Subject: Comments on Seattle Tacoma International Airport Project
Third Runway – Embankment Fill and West MSE Wall, and
Industrial Wastewater System Lagoon #3 Expansion Project
On Second Public Notice

Applicant: Port of Seattle

Reference: 1996-4-02325

Figure 1: Hypothetical Seismic Stability Failure Surface

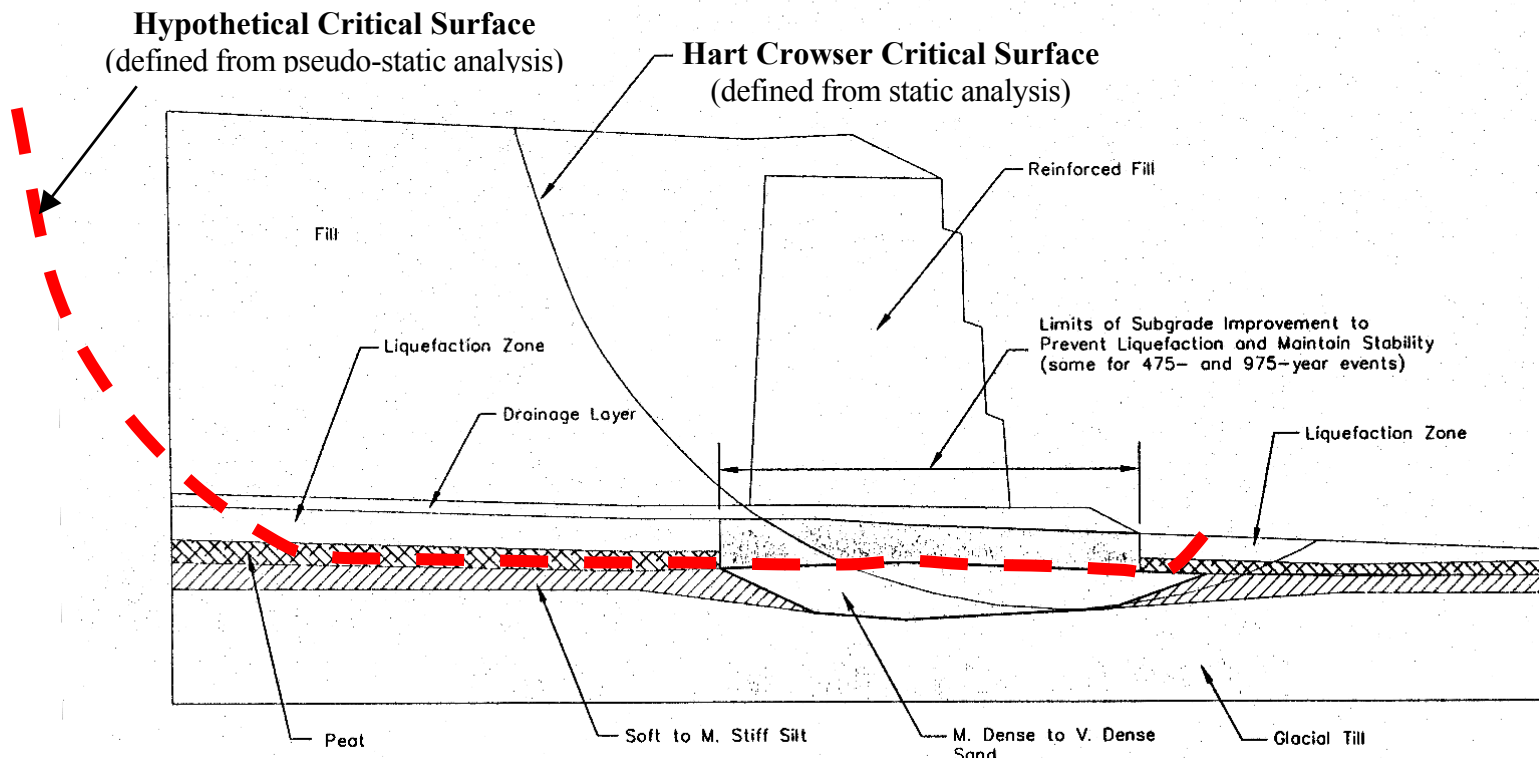
Comment 7: The methodology used in performing pseudo-static (seismic) stability analysis is incorrect and may seriously underestimate the ability of the wall to withstand seismic loads.

According to Hart Crowser, “We typically apply the seismic coefficient to the most critical failure surface identified in the steady-state condition.” No justification is given for using this methodology, and it is in fact incorrect as the critical static (steady-state) and seismic failure surfaces are frequently very different. Under pseudo-static conditions, a horizontal acceleration is applied to the entire failure mass, which acts as a destabilizing force. The computed critical failure surfaces for the seismic case tend to be longer, extending further back into the slope in order to collect more driving mass. The critical surface for the seismic case will also frequently extend along a weak material interface, such as the existing peat layer, or through the liquefied sand deposit.

A proper pseudo-static slope stability analysis should be performed to search for the critical failure surface independently of the static analysis. Additionally, “sliding block” failure surfaces that propagate along the weak seams should be examined, rather

than just circular surfaces that cut across them. The Slope/W program that Hart Crowser is using is well suited to explore these alternate failure surfaces, and to search carefully for an independent critical pseudo-static failure surface. This analysis will likely result in a reduced factor of safety and may lead to requirements for additional ground improvement.

Figure 1 shows a conceptual sketch of a representative failure surface under pseudo-static conditions, extending through the weak peat layer far back into the fill (and potentially beyond the limits of the modeled cross-section). As currently analyzed and designed only the weak soils directly below the wall are being improved. If the critical seismic failure surface extends along the weak peat layer or liquefied zone farther back into the embankment than the static surface, the areas for ground improvement will also need to extend further back in order to remove the threat of these weak soils under a strong earthquake.
